SERVICE BULLETIN No

15-3

**PRODUCTION CHANGE**

SUBJECT: CO / HC PROBE

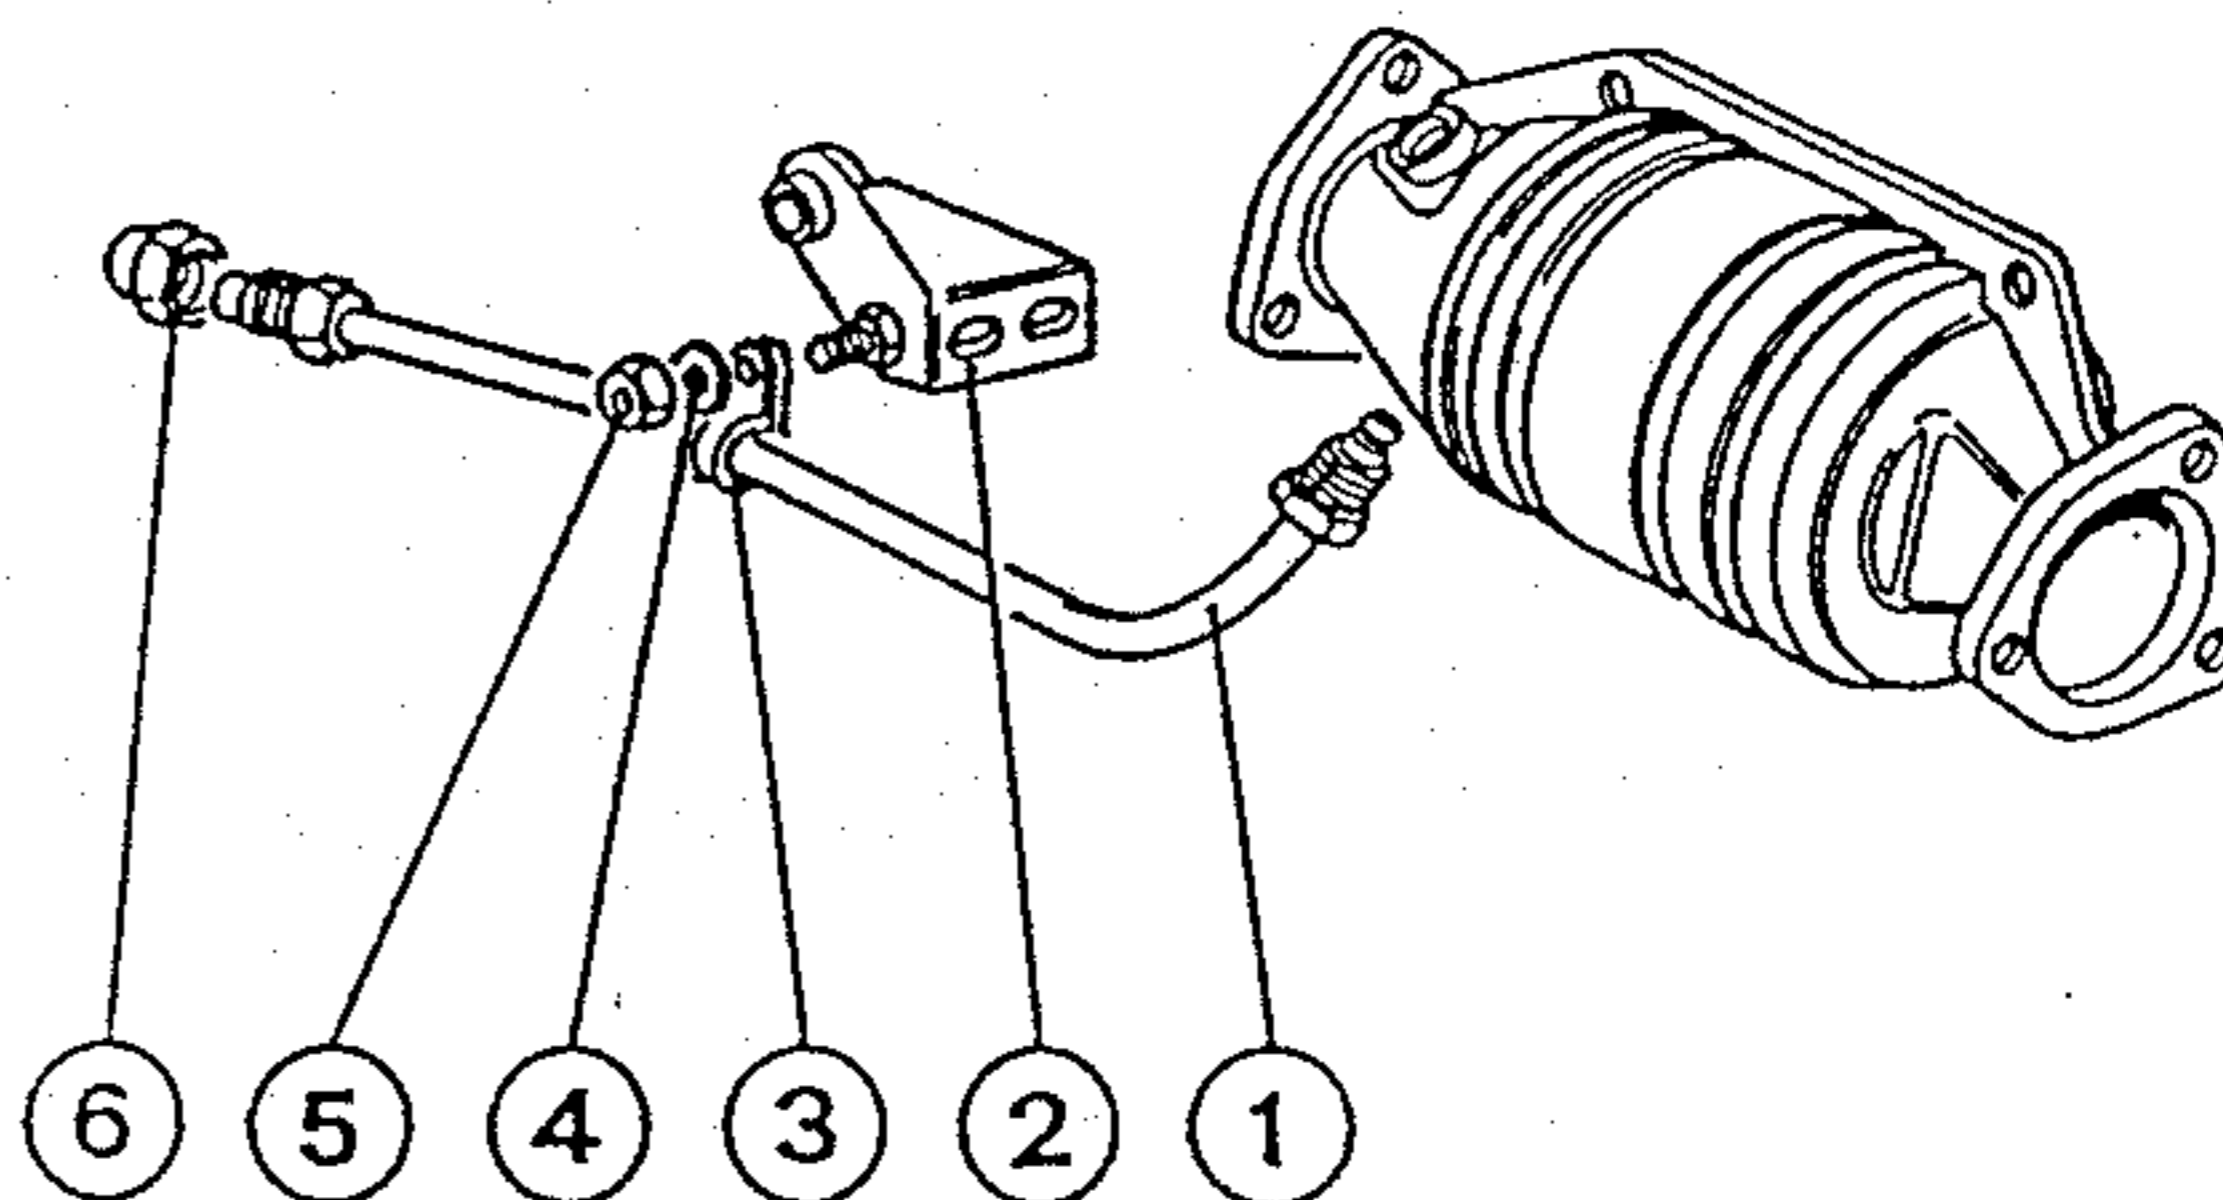
A pipe is installed on the catalytic converter to check CO / HC in order to comply with the new Swiss regulations. The modification is extended on all ( 8 Cyl.) cars provided with catalytic converters.

ref. fig.	Part Number	Description	ref. fig.	Part Number	Description
-	110860	Plug	1	136747	Probe
-	10298460	Gasket	2	136251	Right bracket
			3	10418101	Clamp
			4	12644601	Washer
			5	116416	Nut
			6	16109642	Plug
